**IHL# 201-259**  
**Upgrades & Renovation Poultry Processing Facility & Incinerator Shed**  
**Alcorn State University**  
**Lorman Campus**  
**Project Number: 2021-002**

**Addendum No. 2**

09October2023

DOOR TYPES

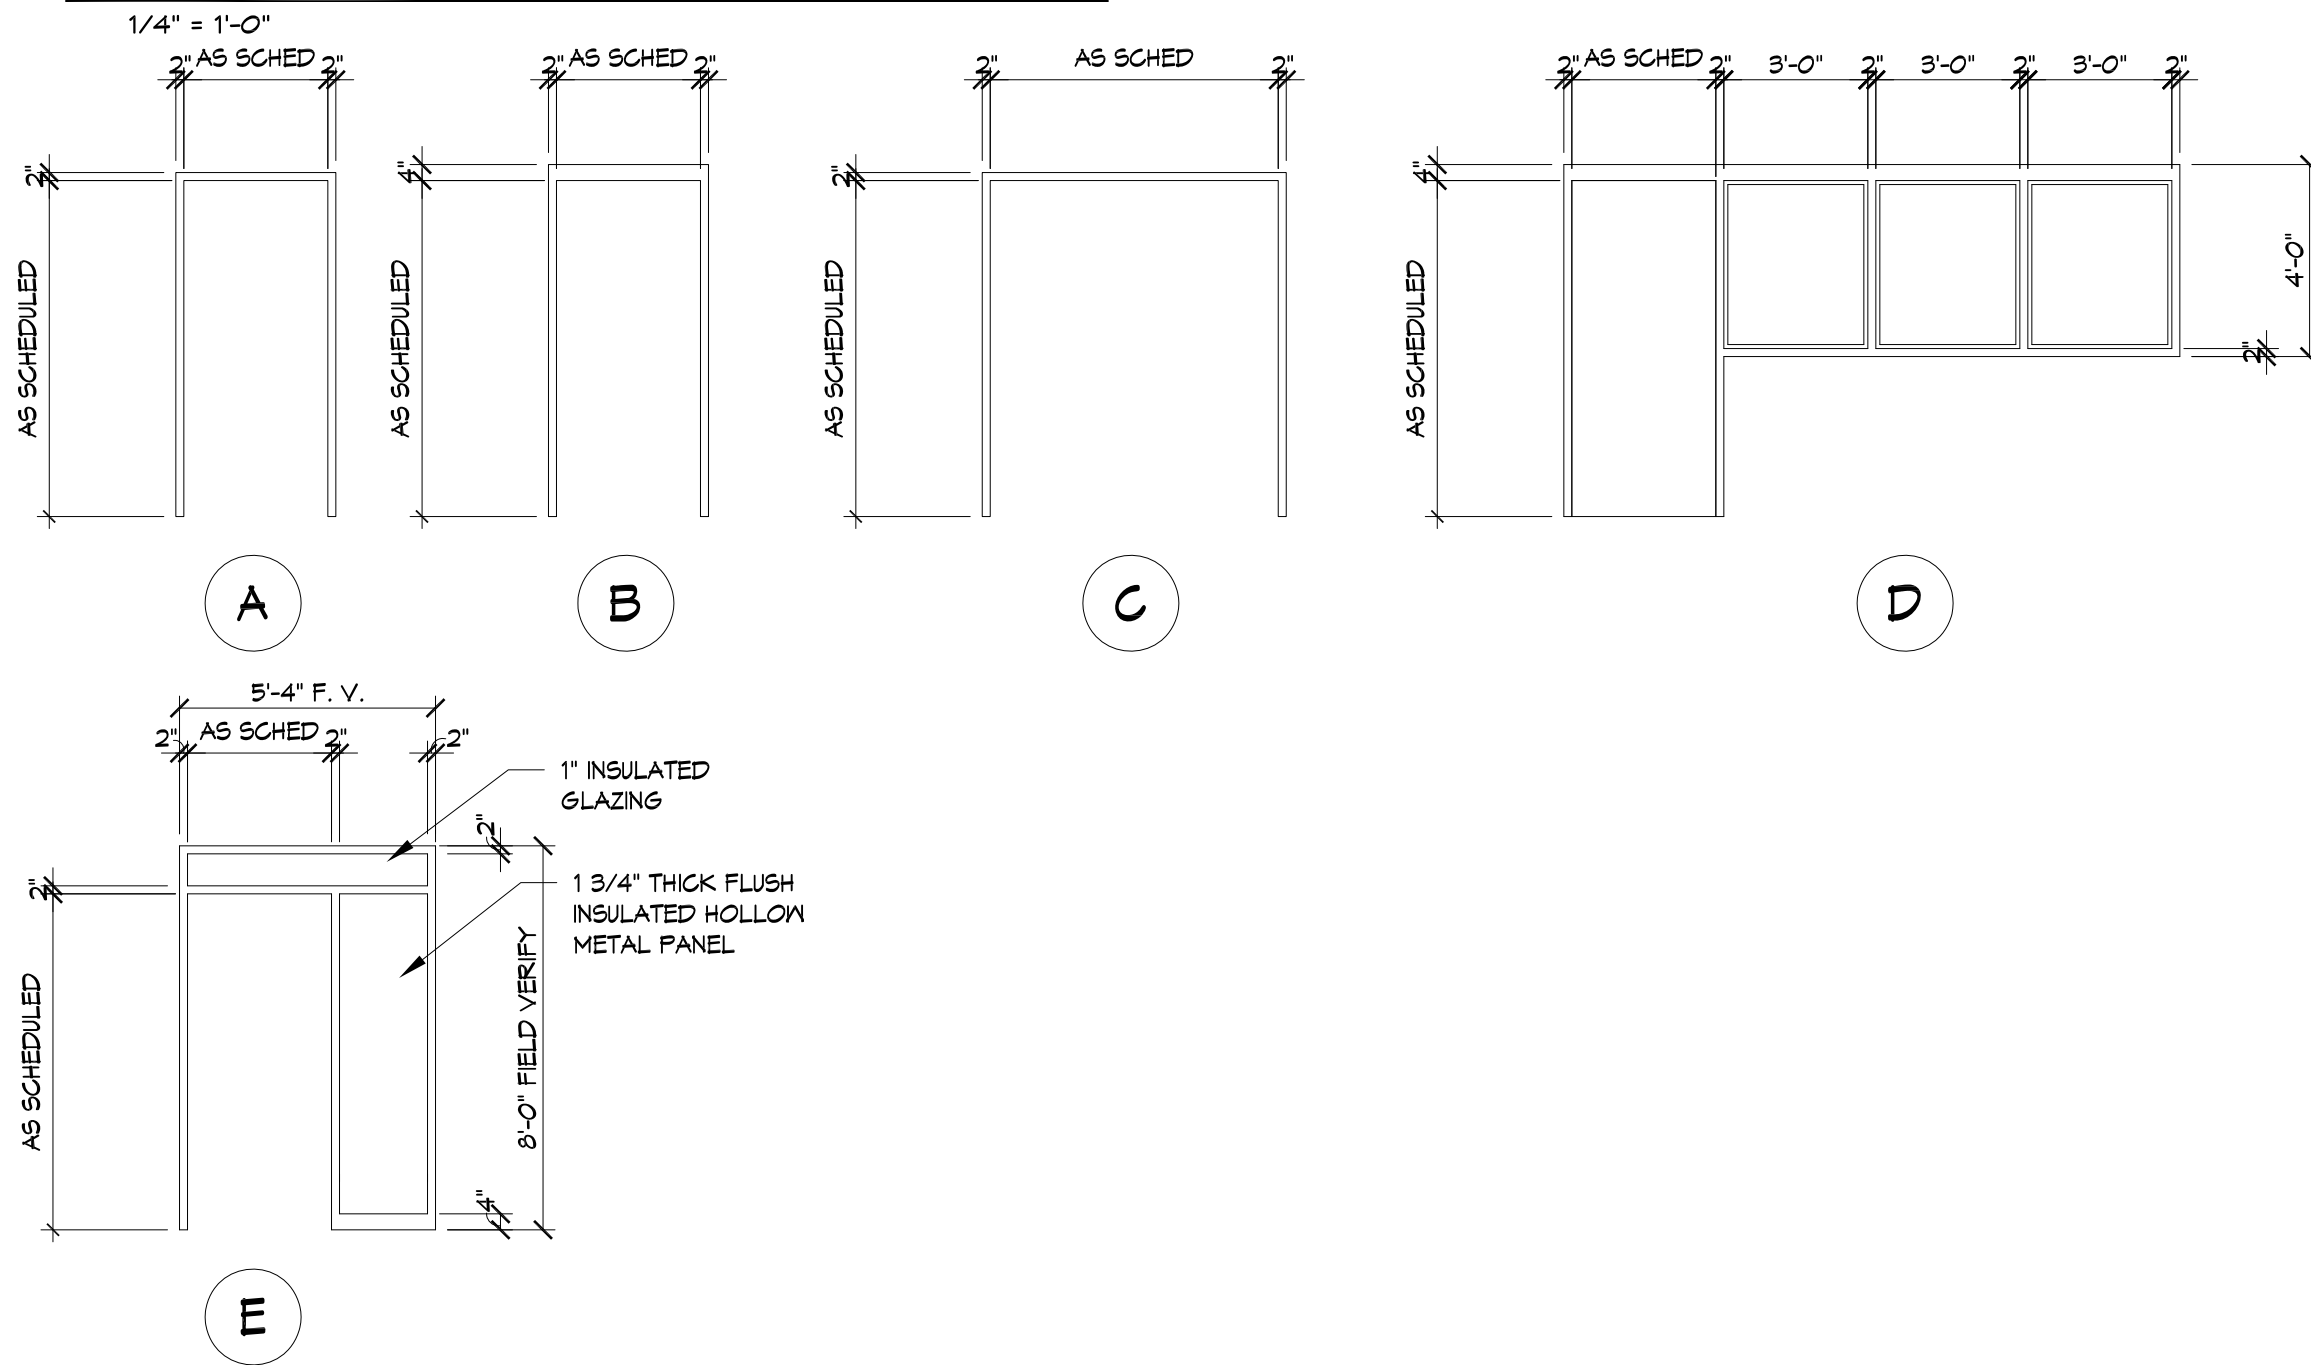
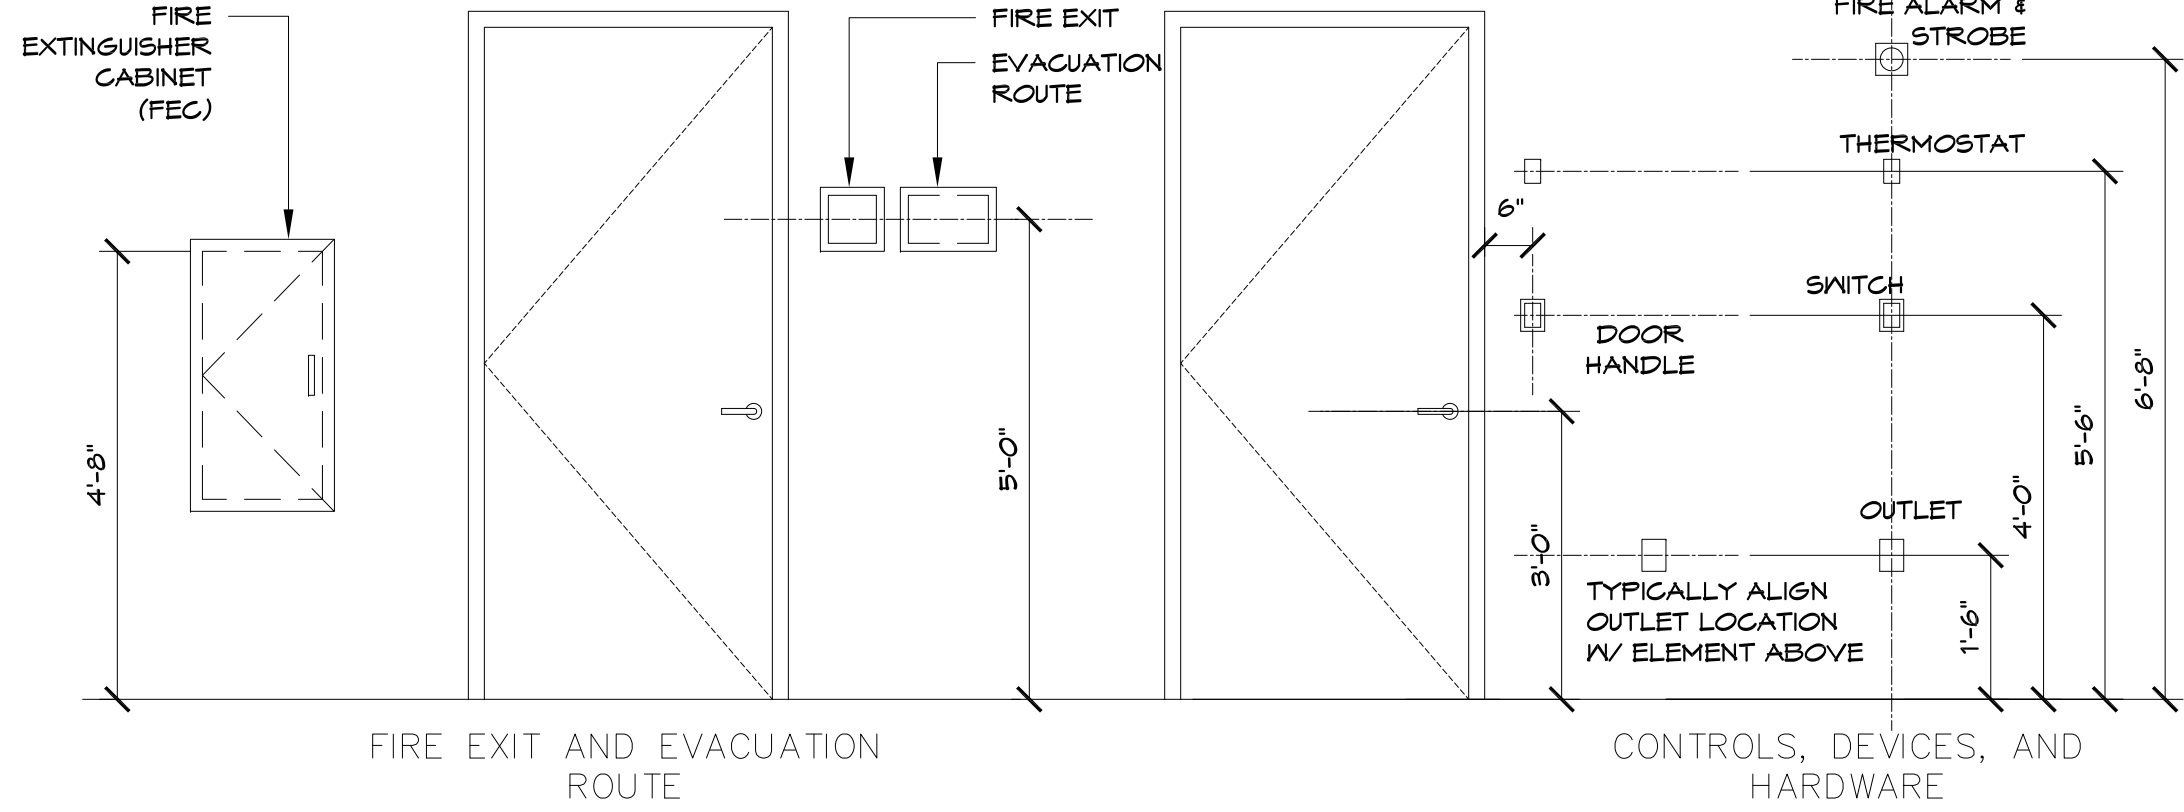
- Item No. 6      Revise: Attached Sheet A-601 – Revise the scheduled glazing for Door Type “B” to non-rated.
- Item No. 7      Revise: Attached Sheet A-601 – Door number 108 frame type from Type “B” to Type “D”.

- Item No. 8      Revise: Attached Sheet A-601 – Door numbers 110A & 110B Door Type “A” to Type “B”.
